Hornsea Project 4 DCO Examination

Post-Deadline 8 Additional Information

Figure 1: Turbine Proximity to Offshore Substation Z12

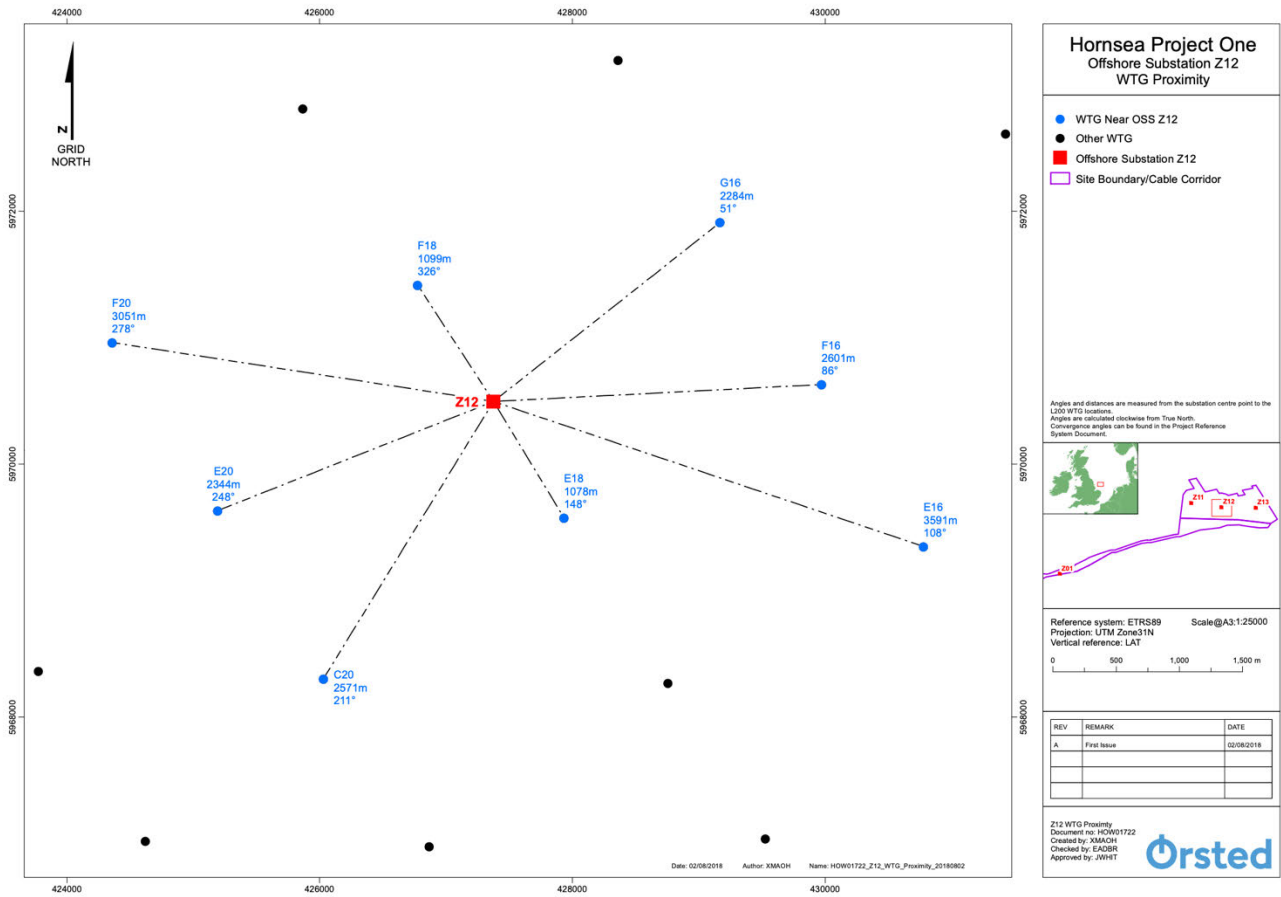
The Applicant cites a precedent of flights using AW139 aircraft and AW169 aircraft to helidecks within the Hornsea Project 1 and Hornsea Project 2 windfarms. Figure 1: shows the distances between the offshore substation Z12 within the Hornsea Project 1 windfarm array and the nearest wind turbine generators (WTGs)¹. Figure 2 shows the layout of wind turbine generators (WTGs) around the offshore substation (OSS) within the Hornsea Project 2 windfarm² upon which we have superimposed the distances to relevant WTGs as estimated from measurements on this diagram. The distances in each case are centre to centre. We understand that Hornsea Project 1 uses WTGs with 154m diameter rotors and Hornsea Project 2 uses 167m rotors. For reference the proposed maximum rotor diameter for Hornsea Project 4 is 305m³ (REP1-004).

Unless rotors are stopped, this would mean that the available free airspace is reduced by the blade length(s). In both the case of Hornsea Project 1 and Hornsea Project 2 it is apparent that:

- (i) No turbine has been placed less than 914m from a helideck;
- (ii) Most neighbouring WTGs are at significantly greater distances (nearer to 2km) from the helideck;
- (iii) The Hornsea Project 2 OSS is close to the southeastern edge of the array, such that it can be accessed through a very short, wide (~3km) corridor through which there would always be visibility under Visual Meteorological Conditions.
